ADDENDUM No. Three

Project Name: Auburn Heights State Park – Farm Lane Bridge & Snuff Mill Bridge Abutments

Project No.: NVF-11

Date of Issue: January 2, 2019

Boring Location Plan
Century – Auburn Heights State Park Farm Lane Bridge
Yorklyn, Delaware

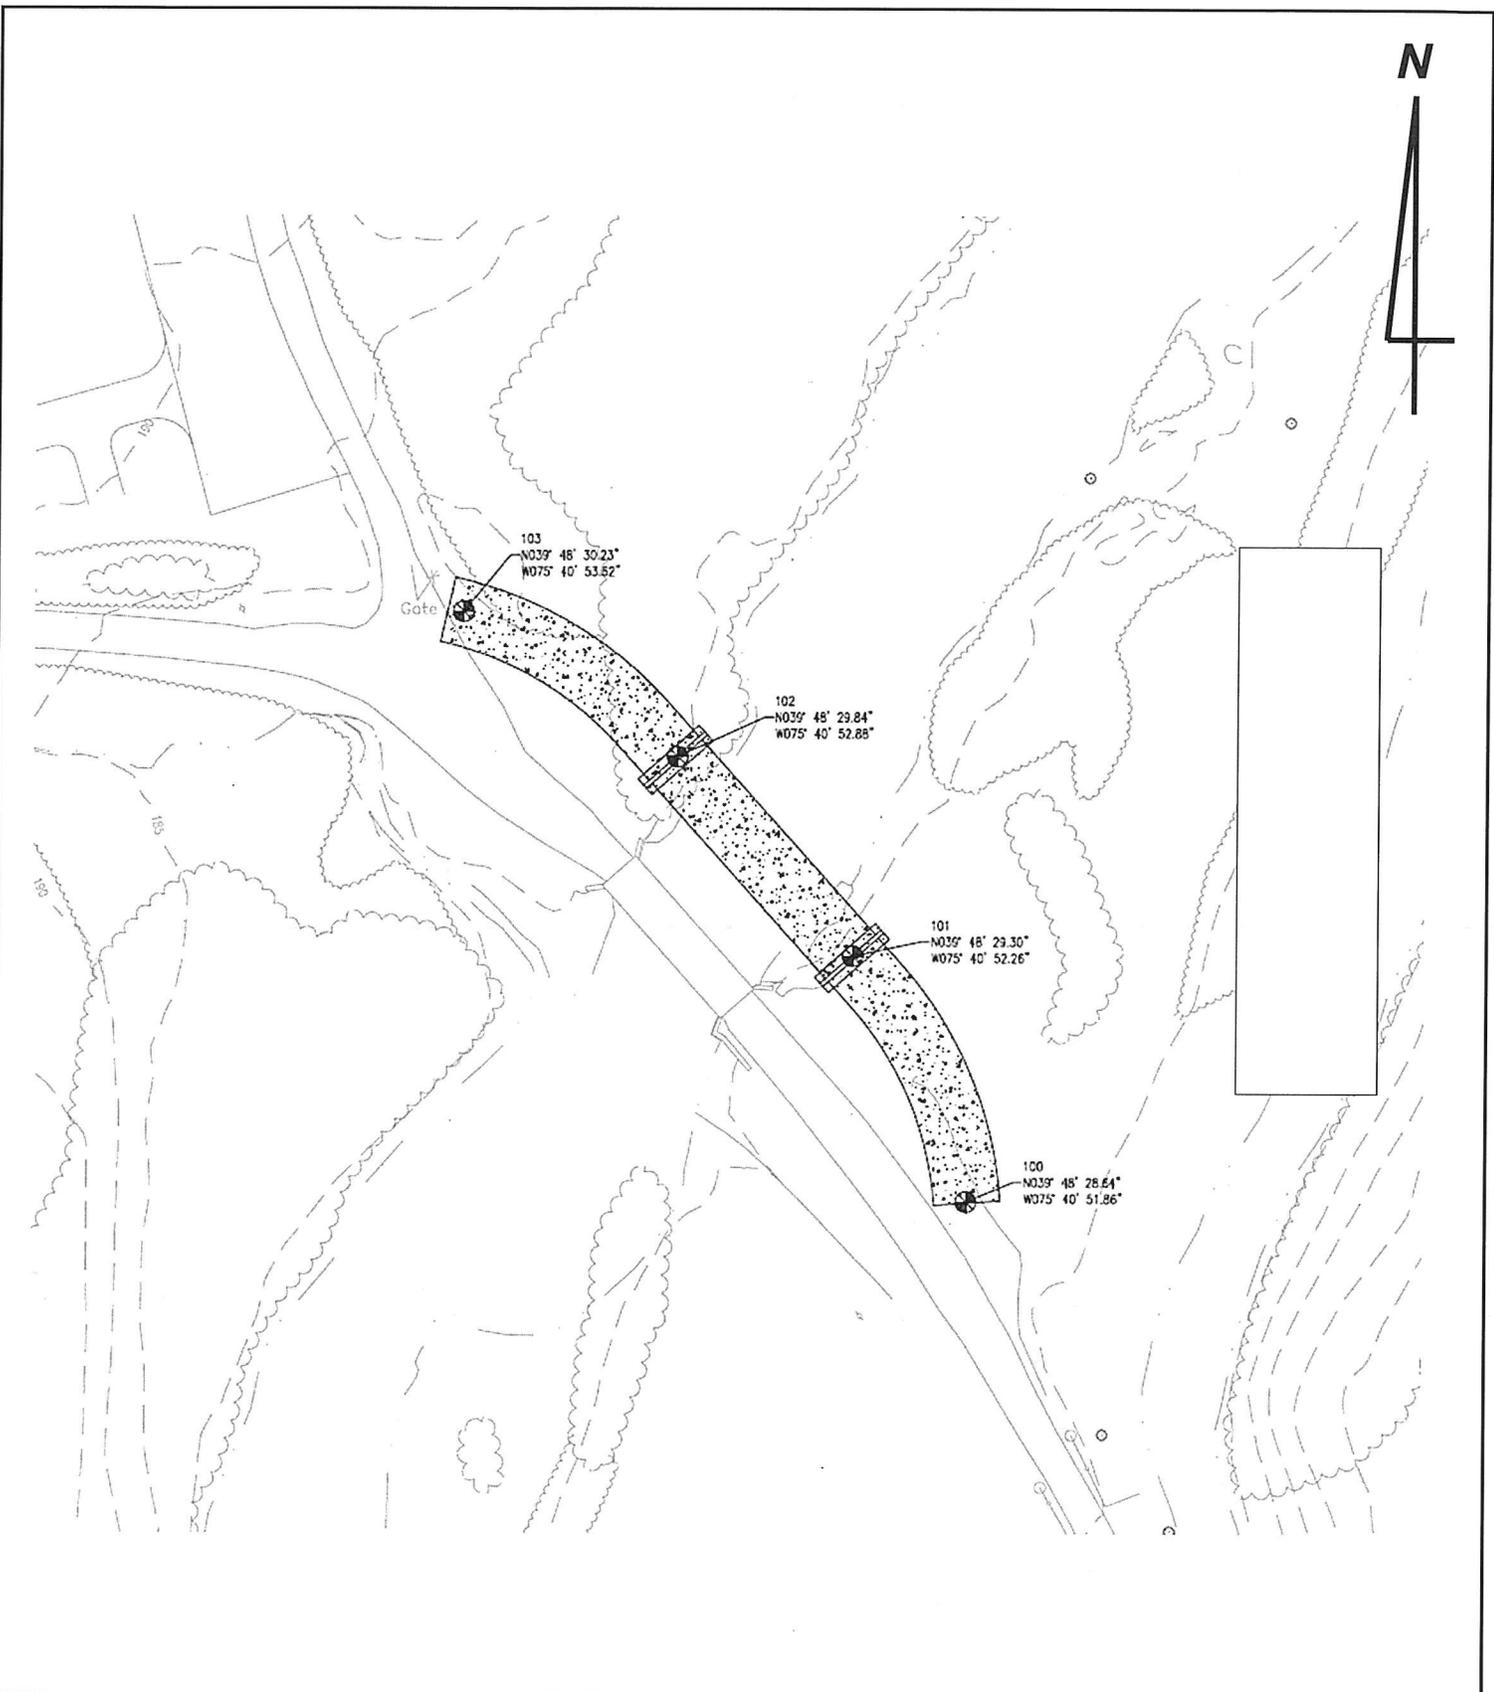
2. The plans require the contractor to design a support of excavation / cofferdam system for the piers. The plans also indicate rock at a high elevation. In order to properly evaluate our options, please provide any soil boring the Department may have.

- [Borings for the Snuff Mill Bridge are in the Contract Plans, Sheet S706. Borings for the Farm Lane Bridge are included with this Addendum.](#)
3. The plans (Sheet S602 & S702) indicate details for excavation and backfill with support of excavation and an alternate detail for sloping of the excavation. Given that the work is in close proximity to stream / roads, and that the plan view indicates support of excavation is required, please explain what is the purpose of the alternate detail?
